USD 307 EII-Saline Remodel Science Rooms Middle-High School – Proj 22-3284

ADDENDUM NO. 2

D **STORAGE #207**
NORTH CASEWORK ELEVATION
 3/8"=1'-0"

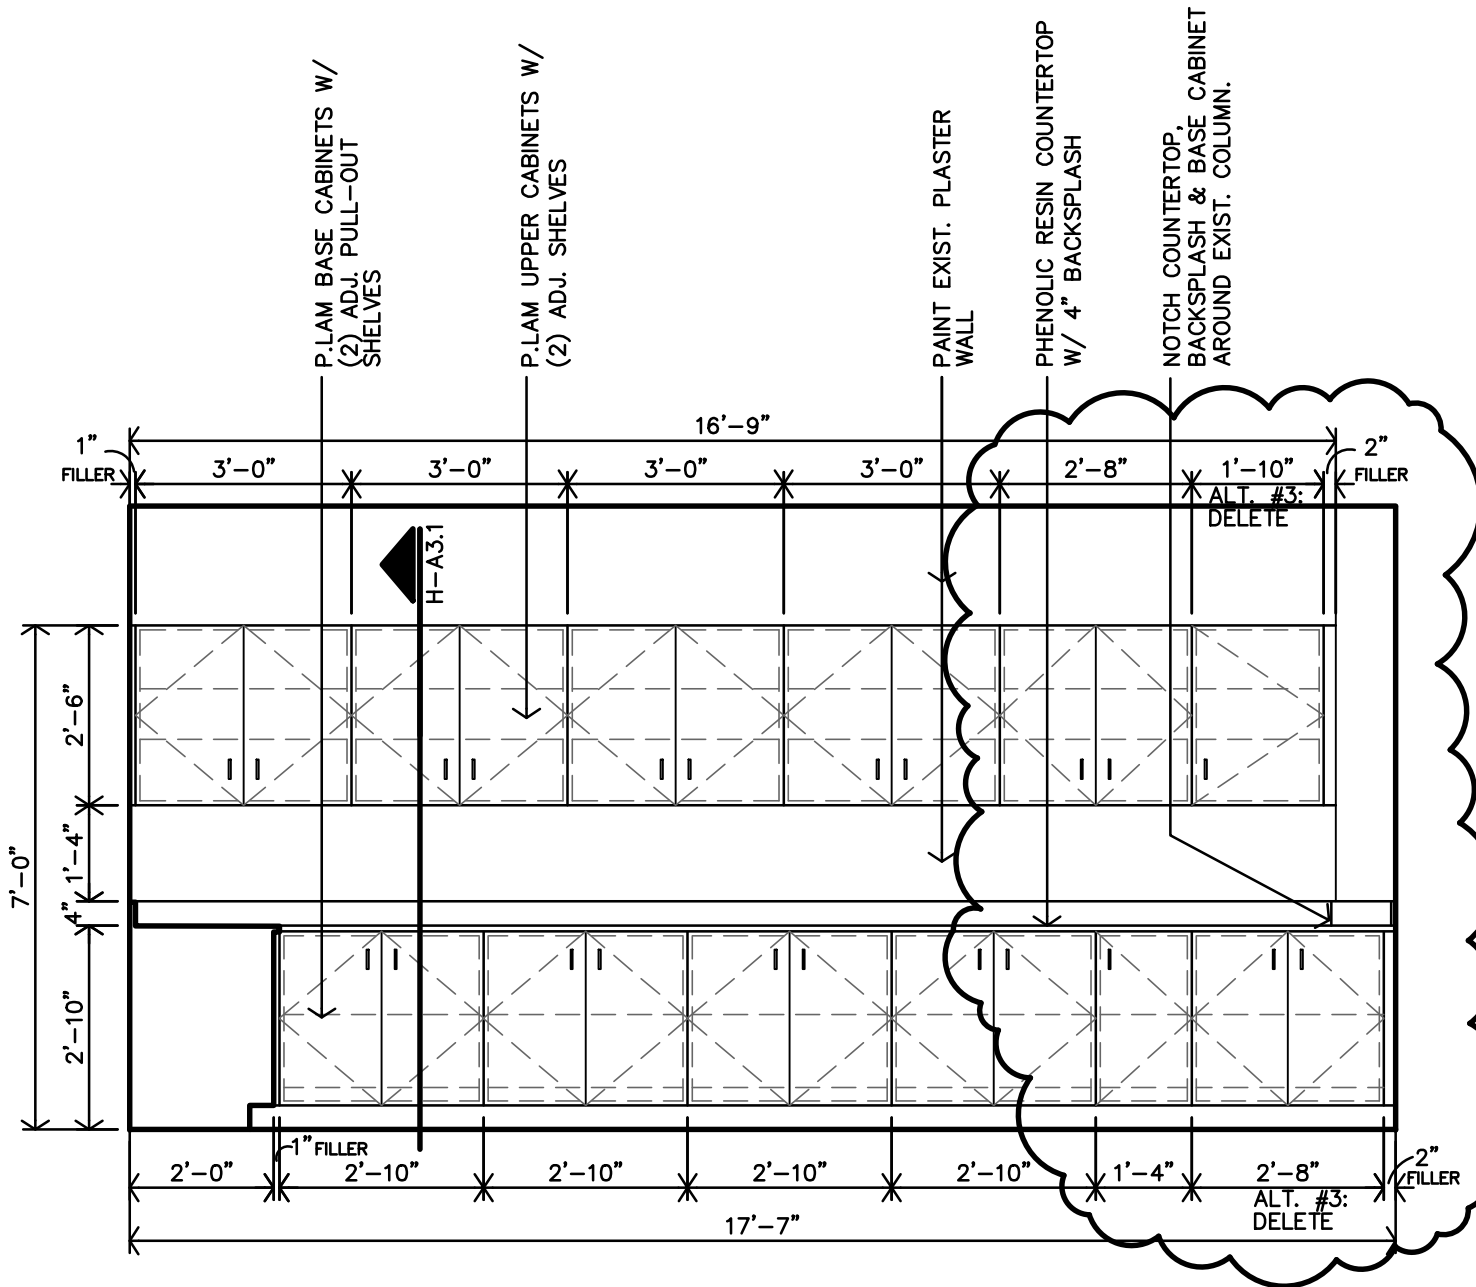
1. Casework Revision Sheet 1 (attached) – Casework size has changed slightly to accommodate Alternate #3 work (if selected).
2. Sheet A10.1, Window Schedule Alternate Bid #1 – Note #6 clarification: For bidding purposes, contractor shall be Corian, Grade 3/C solid surface material.
